SafeWorks, LLC
365 Upland Dr.
Seattle, WA 98188

SafeWorks, LLC is seeking a Class II permissive change for model IBEX 1000, FCC ID: W35-1000. The changes are to non-RF components and are electrically similar to the existing design. The changes are to the battery and charging circuit, the directional switch, and an update to the most current version of the microprocessor.

Old Charging Circuit

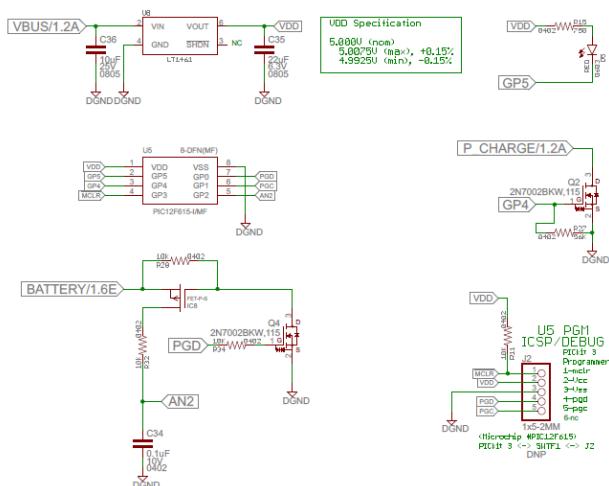
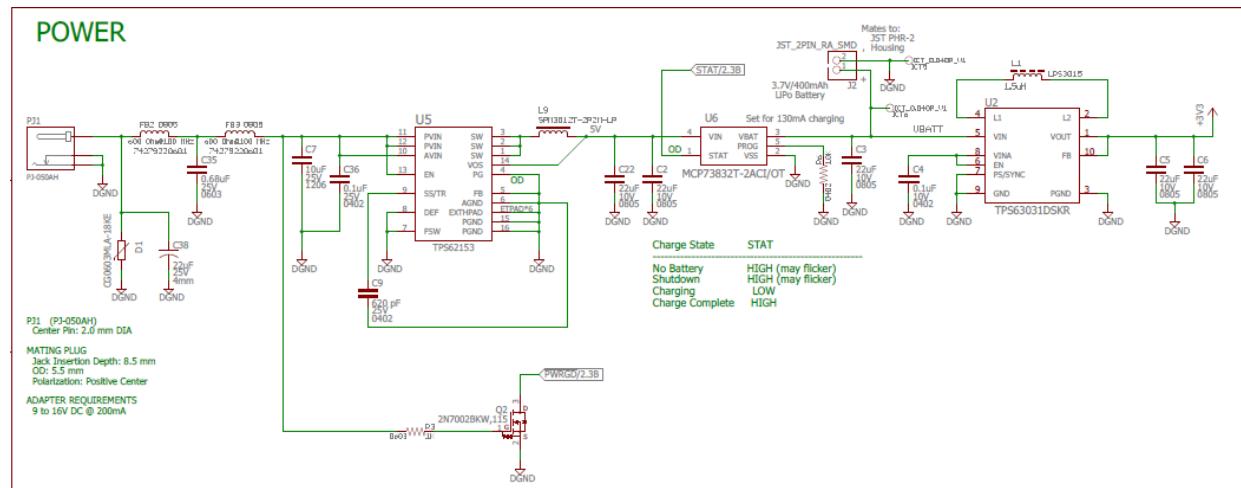
The battery was a 2cell 2.4Vdc 800mAh NiMh. It has been changed to a single cell 3.7Vdc 400mAh LiPo battery. The charging circuit was changed correspondingly. See below for the differences (See Appendix for full schematic)

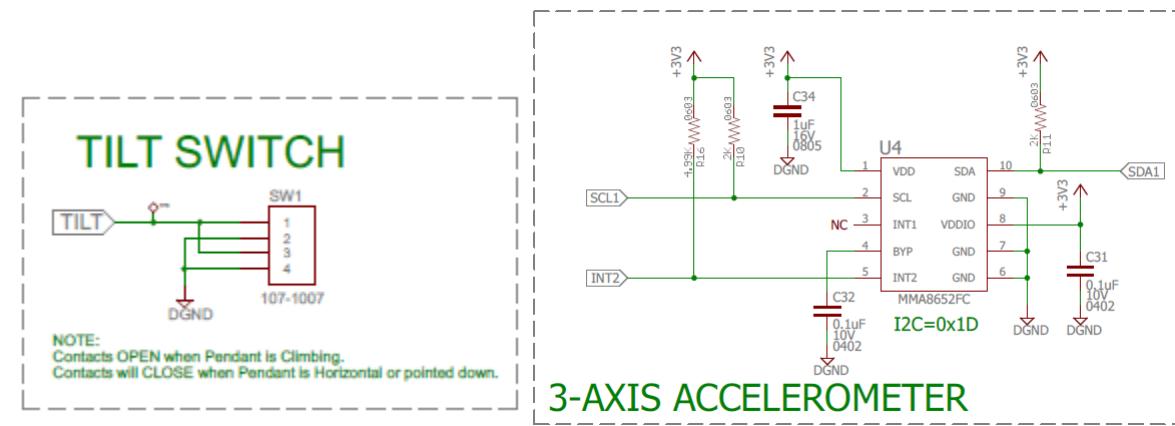
The tilt switch was replaced with a 3-axis accelerometer. See below:

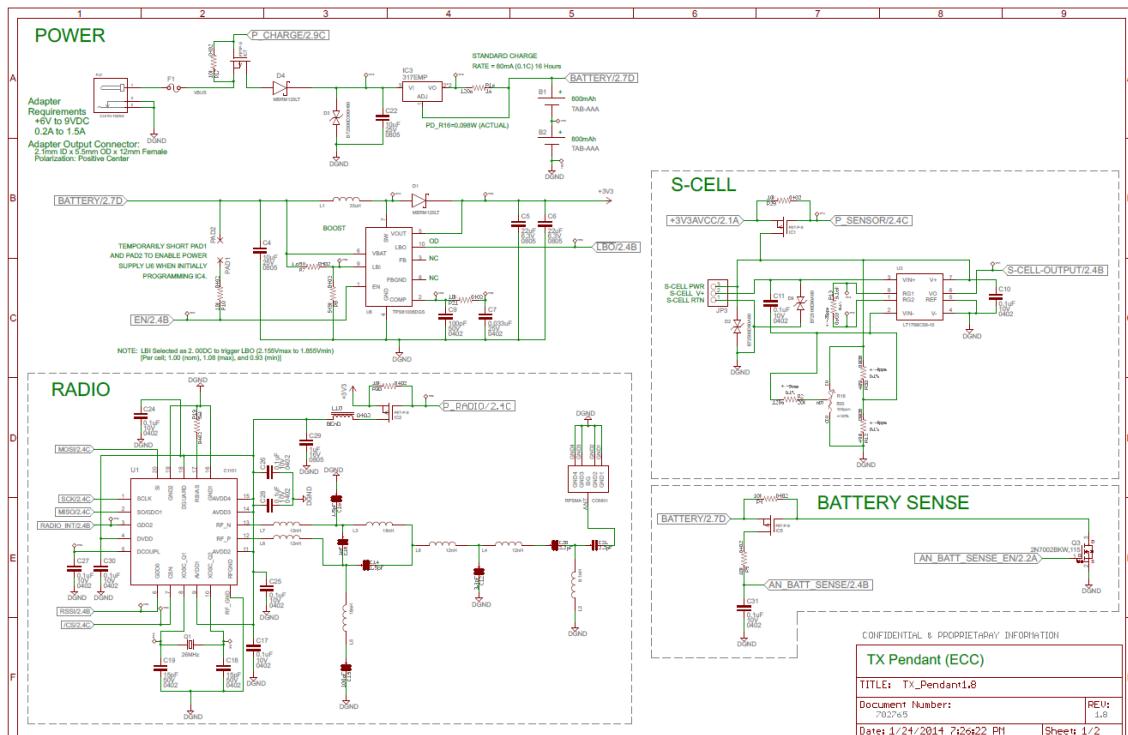
The Microprocessor ATMEGA328-AU was replaced with ATMEGA328PB-AU.
